COMMUNITY DEVELOPMENT DEPARTMENT REPORT

HEARING DATE: 4/3/2025
Continued from: 3/6/2025

APPLICANT: Rodney Evans + Partners, LLC

SUBJECT: [H-2024-0059](#)
Latitude Forty Three Subdivision – AZ, PP

E. Common Driveway Exhibit

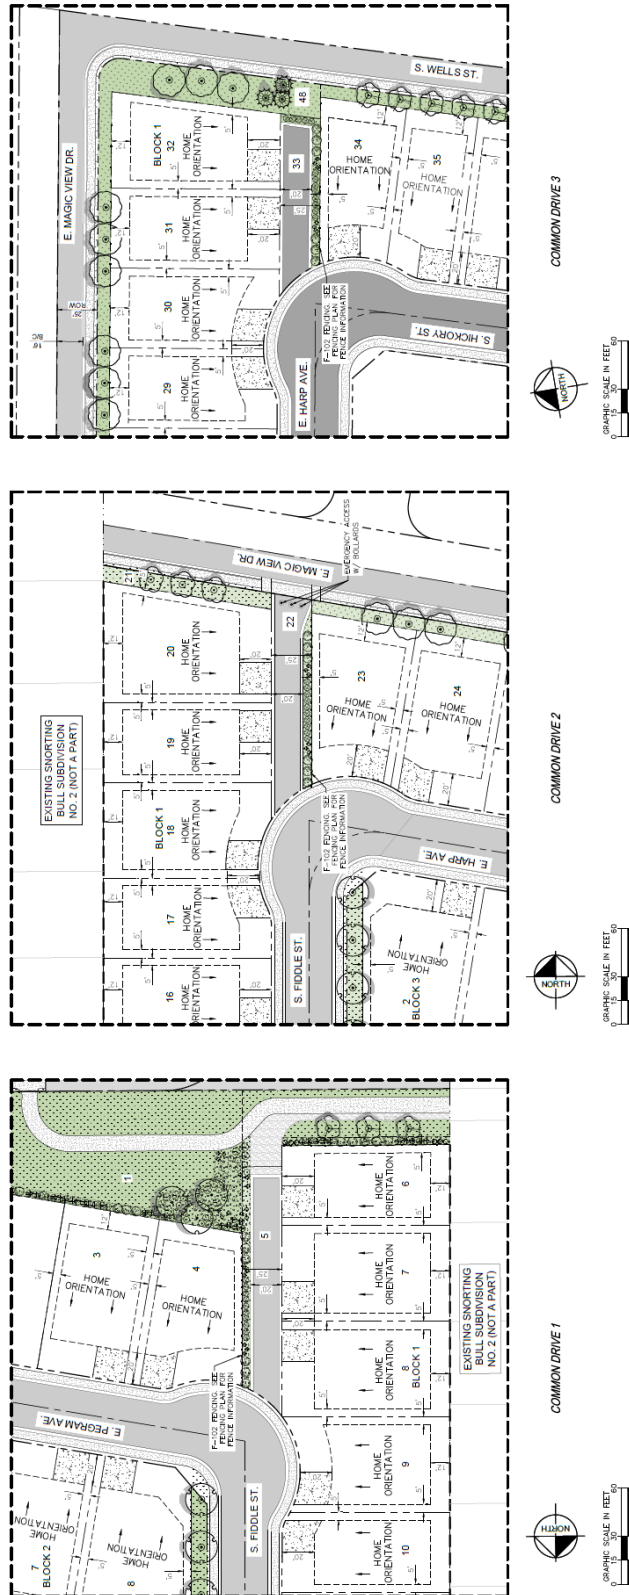
- xii. Depict a minimum 5-foot wide temporary asphalt pathway along Wells St. if there is adequate area alongside the existing road.
4. The common driveways shall be constructed in accord with the standards listed in UDC 11-6C-3D and building setbacks shall be as shown on the common driveway exhibit in Section VII.E.

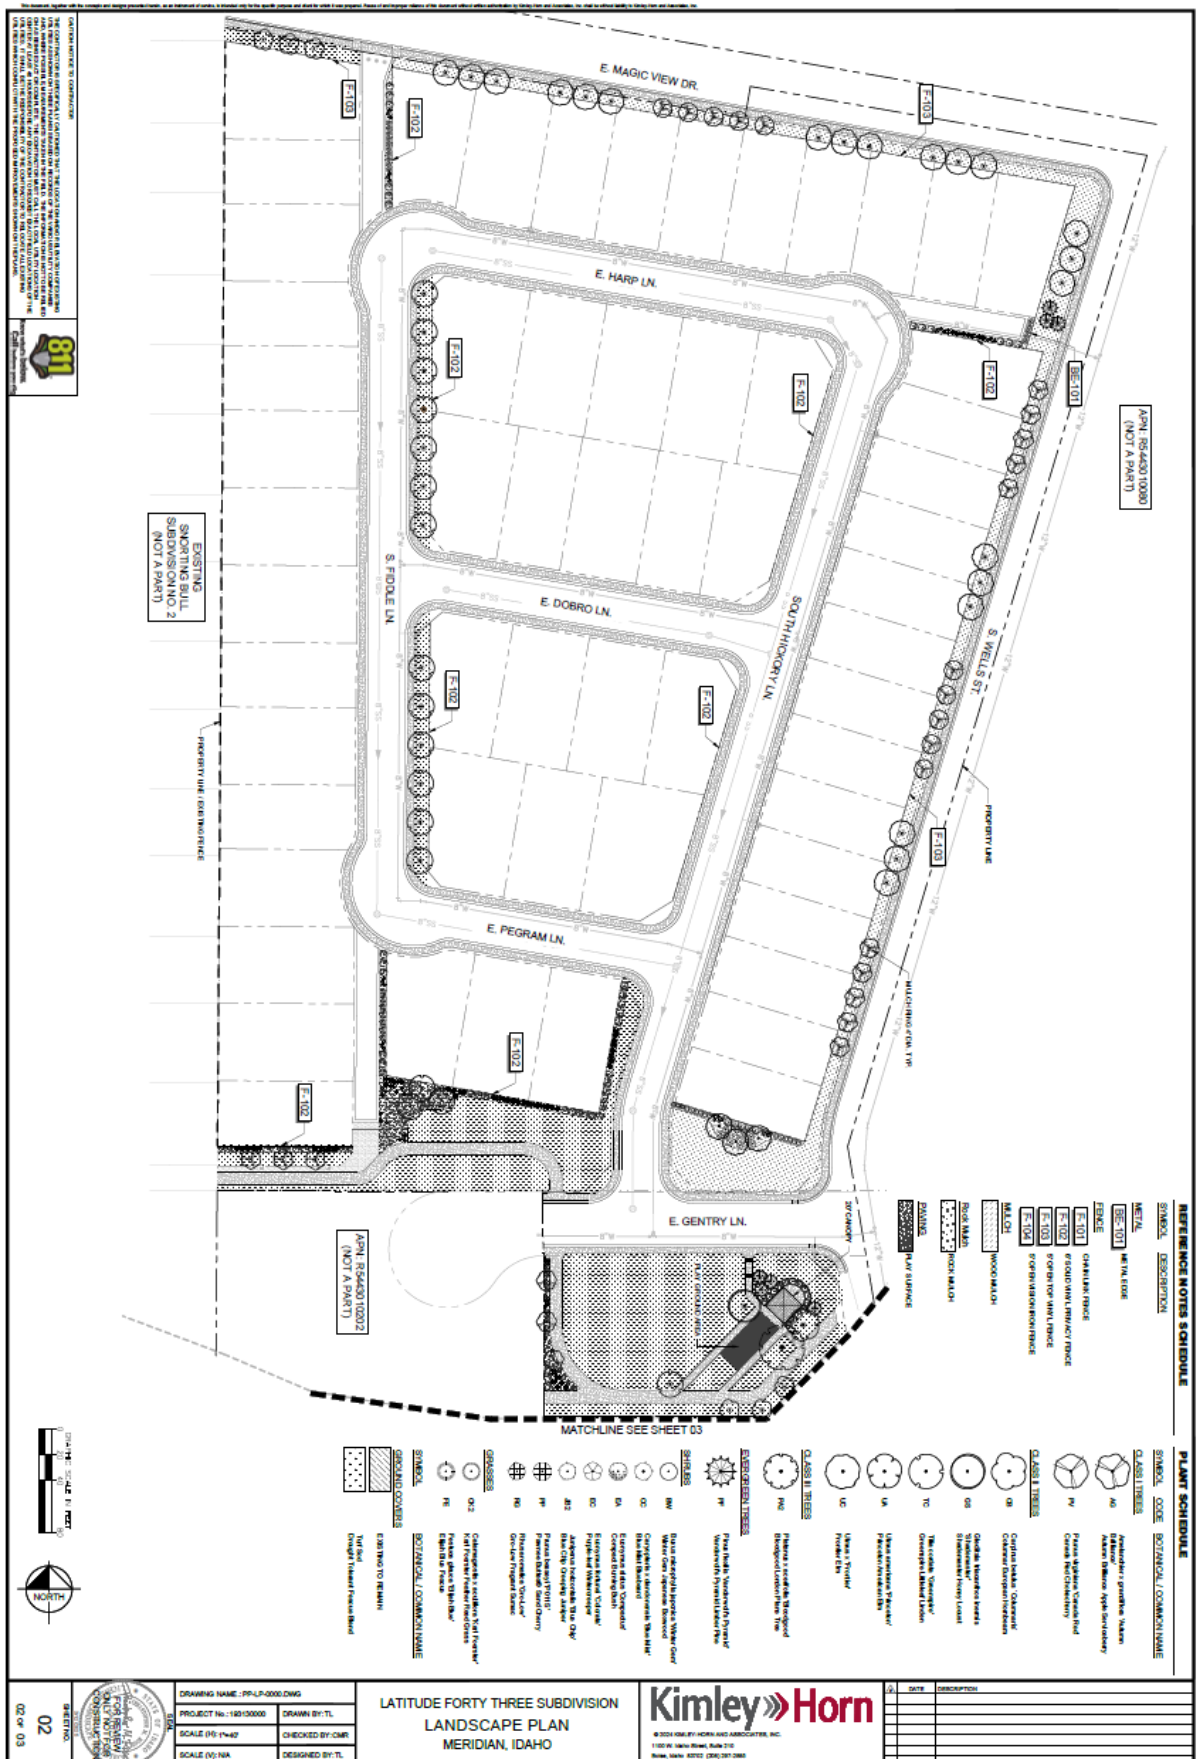
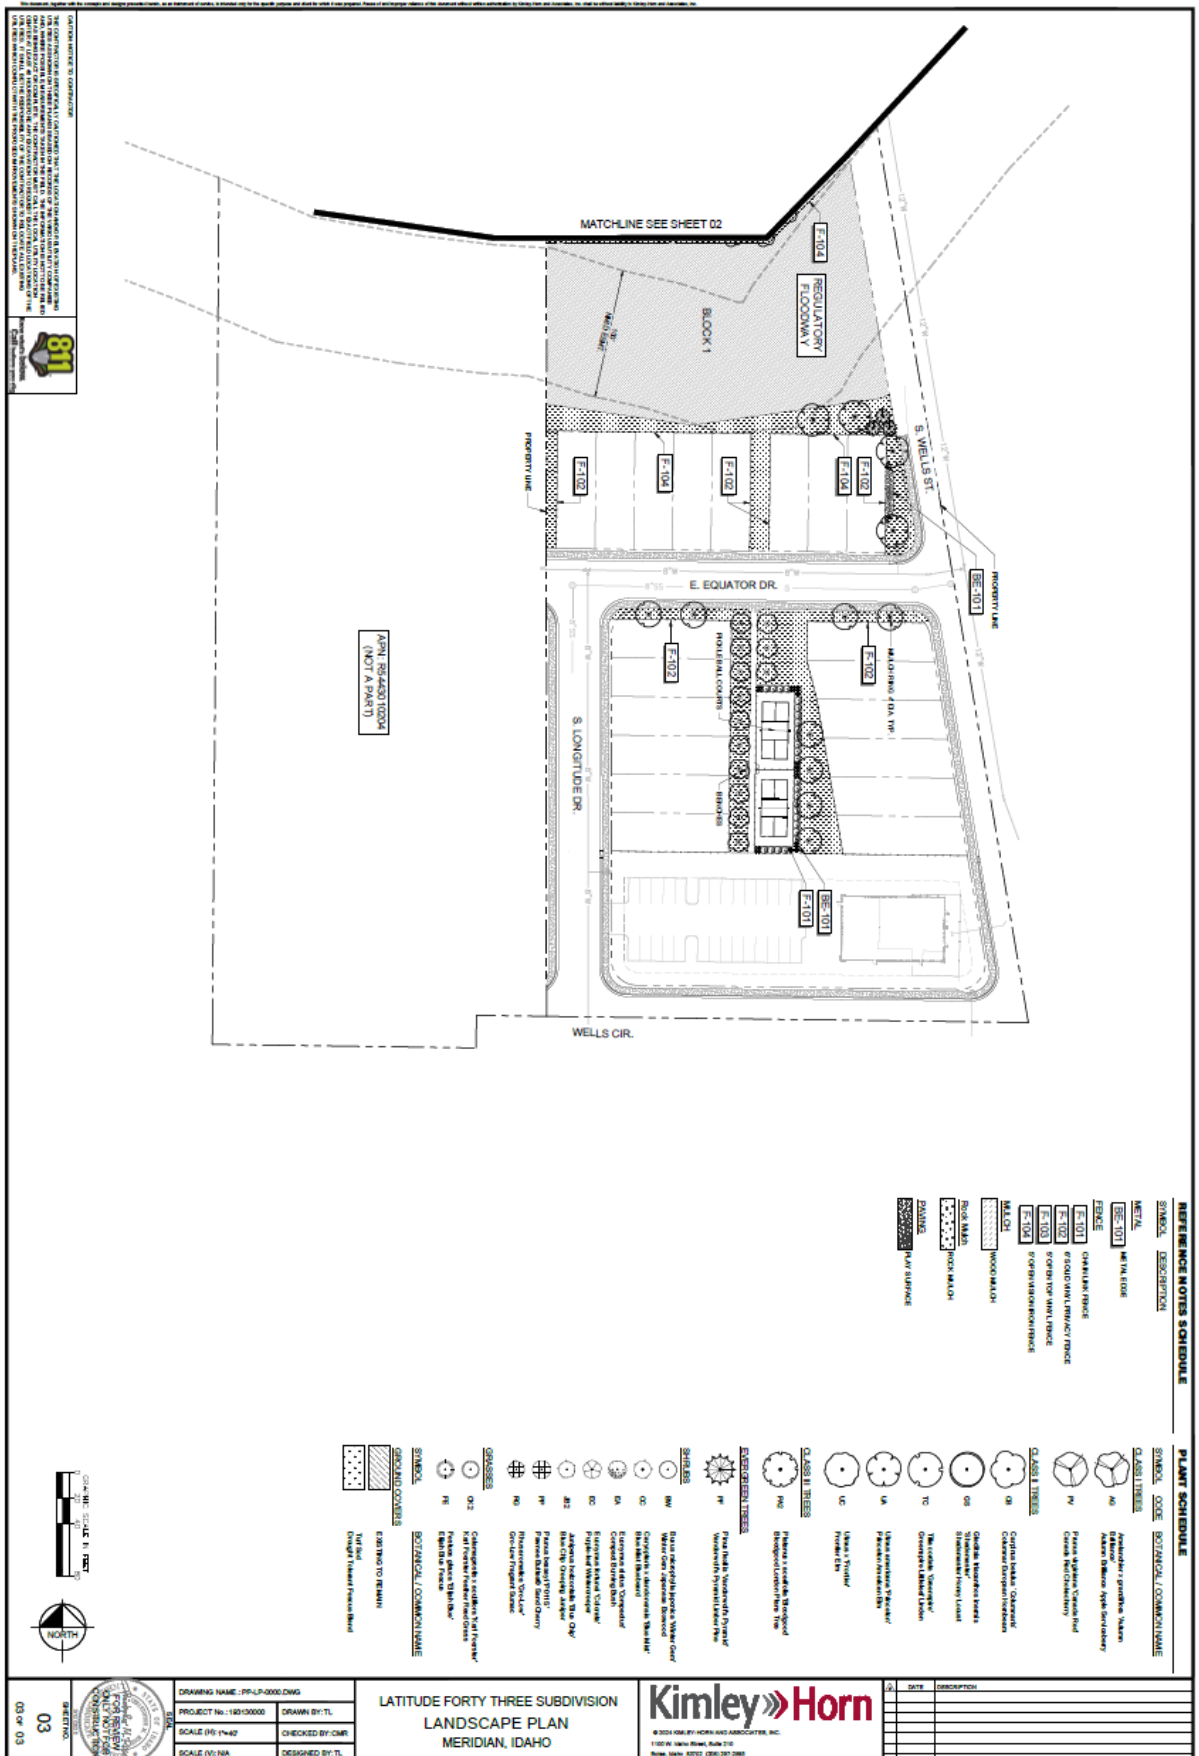
- vi. Fencing along S. Hickory St. on Lots 5 and 6, Block 2 and Lots 6 and 7, Block 3 shall be depicted a minimum of 10-feet from the street side property line per UDC 11-3A-7C.3.

- vii. The maximum fence height in the required front yard including the front and side yard property lines shall be 3-feet for a closed vision fence and 4-feet for an open vision fence per UDC 11-3A-7C.2; revise accordingly.

- x. Widen the street buffer along E. Magic View Dr. and S. Wells St. to allow for a 10-foot wide minimum setback for perimeter fencing from the property line in accord with UDC 11-3A-7C.3.

- xi. Remove the fencing depicted along the north side of the Fivemile Creek and depict 6-foot tall wrought iron fencing along the south side of the Fivemile Creek for public safety, unless otherwise modified by City Council.
